SECTION 009113  
ADDENDUM NUMBER 3

- 1.1 DATE: December 29, 2021
- 1.2 PROJECT: Orangetown Town Hall Addition and Alterations
- 1.3 Owner: Town of Orangetown
- 1.4 Architect: Lothrop Associates LLP Architects

SITE PLAN, BACKFLOW  
PIPING AND NOTES

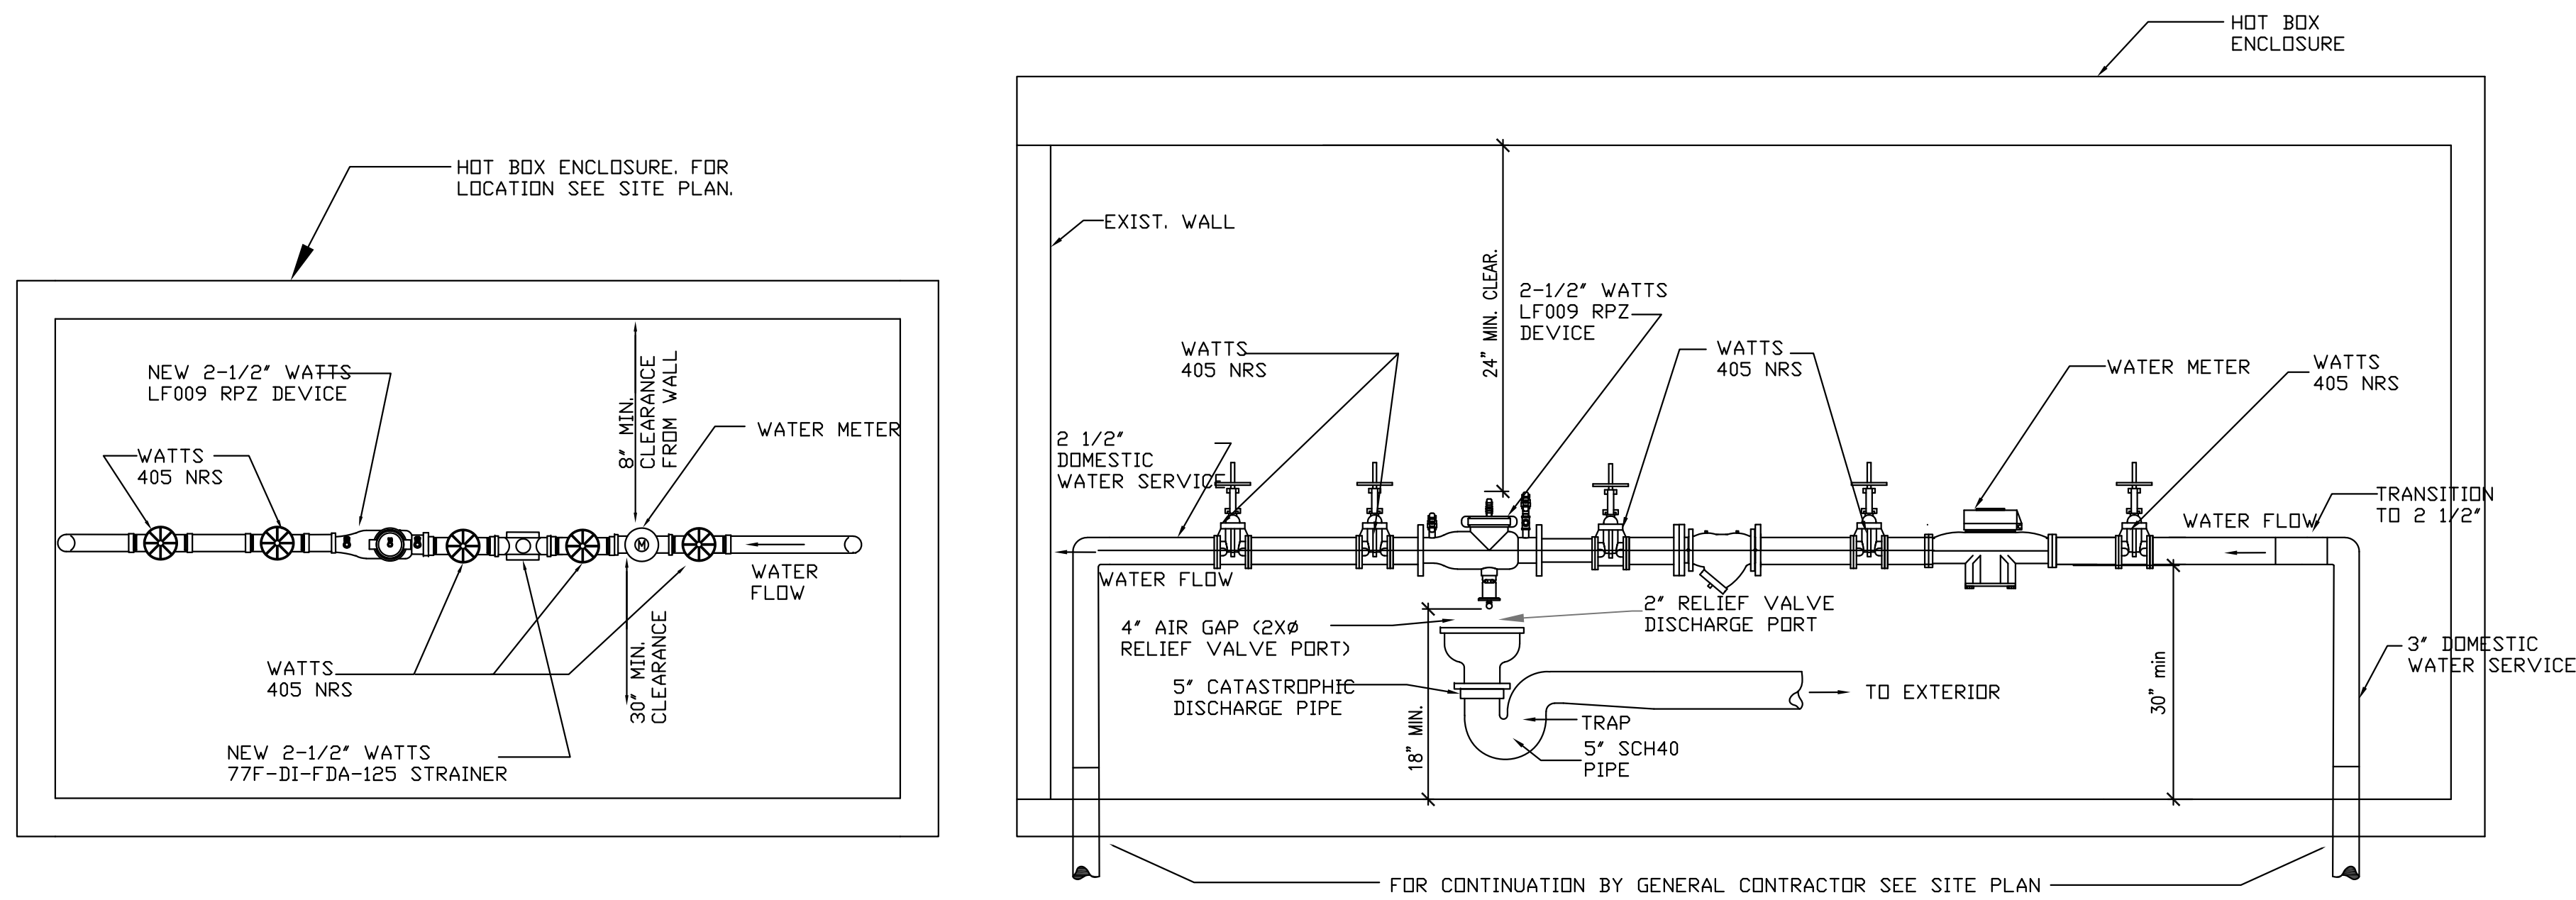
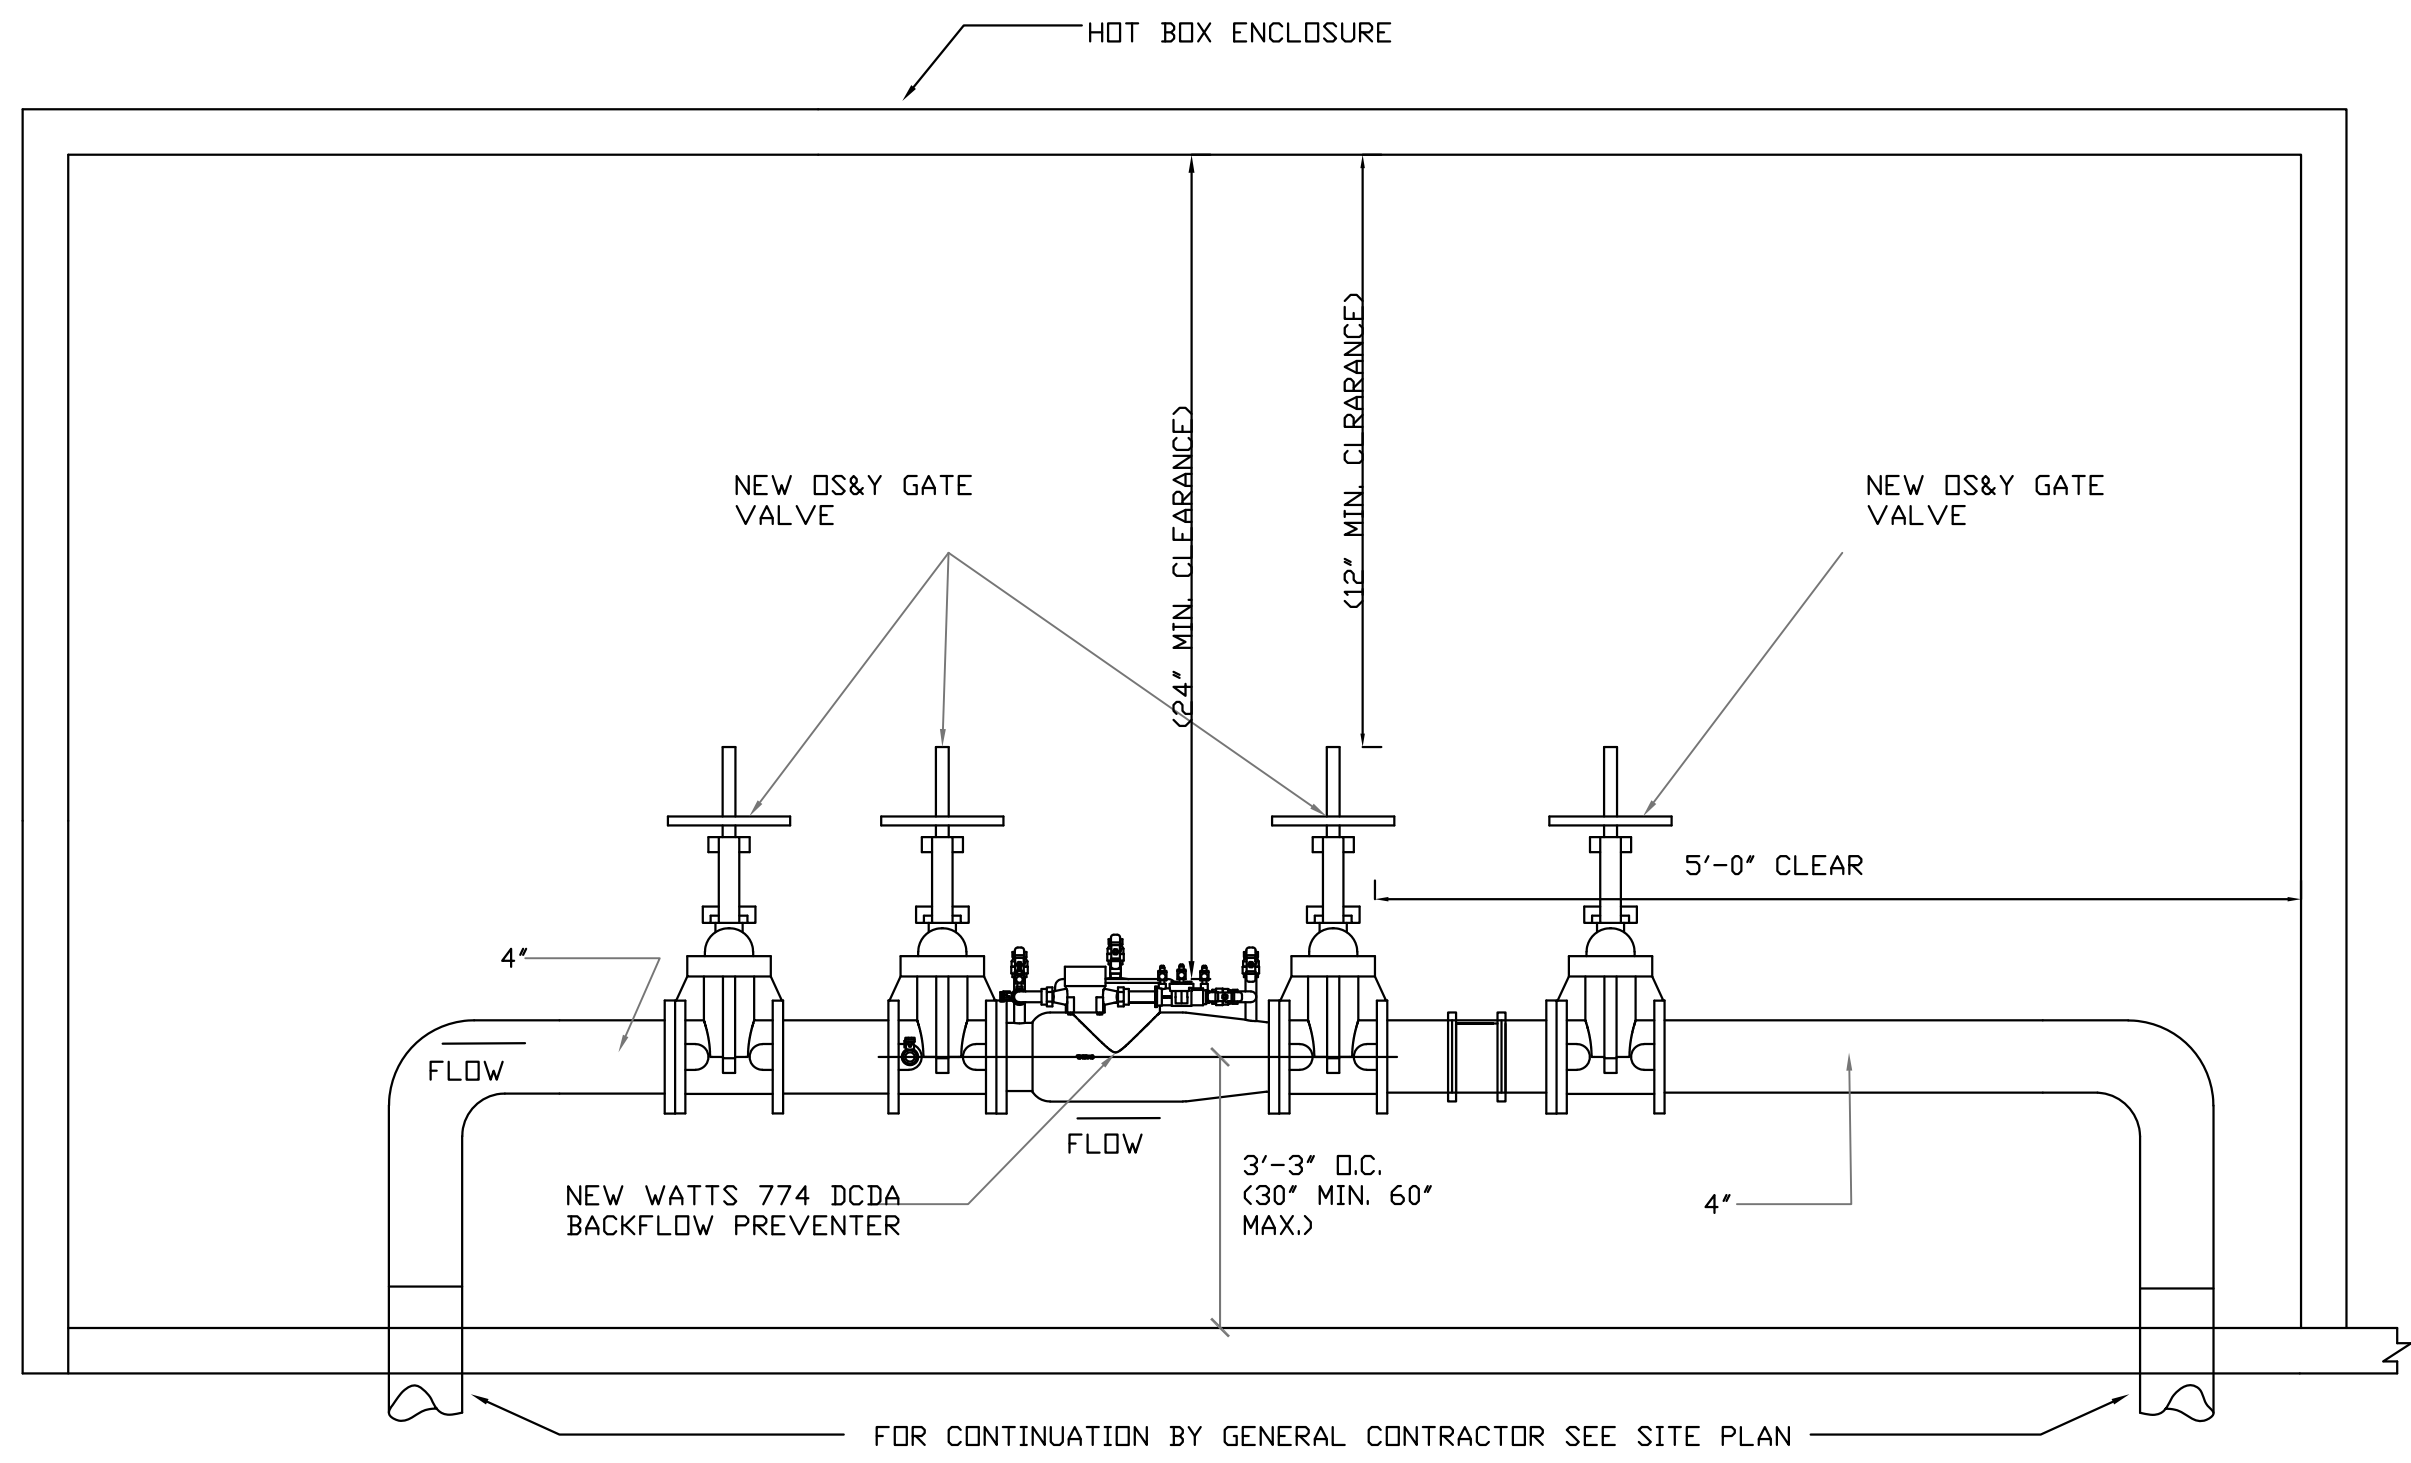
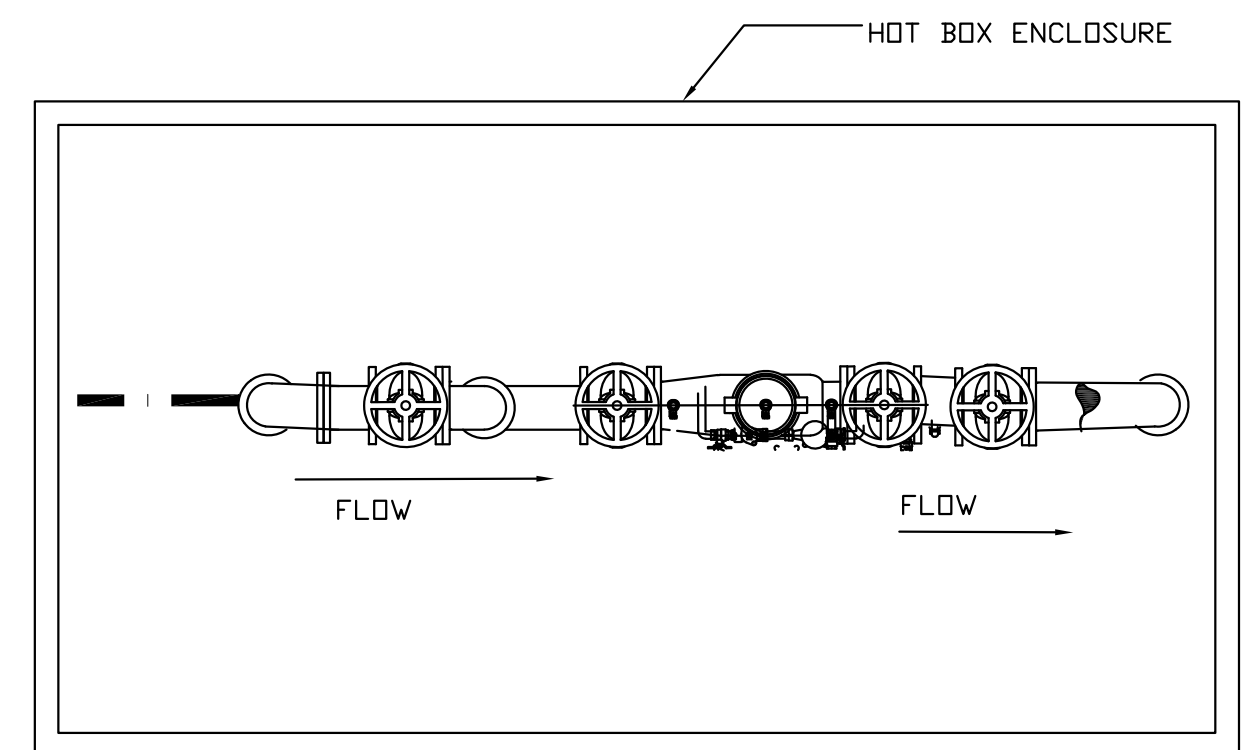
45. Please clarify the responsibility for the gas piping work on site. (Architect's RFI #1G.08)
- a. **The Plumbing Contractor is responsible for the installation of gas piping on site. See revised drawing P-206, attached to this Addendum.**

- APPROXIMATE LOCATION OF DOUBLE CHECK VALVE AND RPZ ON SITE. FOR ACTUAL LOCATION SEE SITE PLAN.
- NEW 2" GAS PIPING IN TRENCH PROVIDED UNDER THE GENERAL CONSTRUCTION WORK. COORDINATE CONNECTION TO NEW GAS SERVICE WITH UTILITY COMPANY.
- CONNECT NEW GAS PIPING TO EXISTING METER STATIONS FOR AT&T AND VERIZON GENERATORS.
- NEW GAS SERVICE INTO BUILDING.
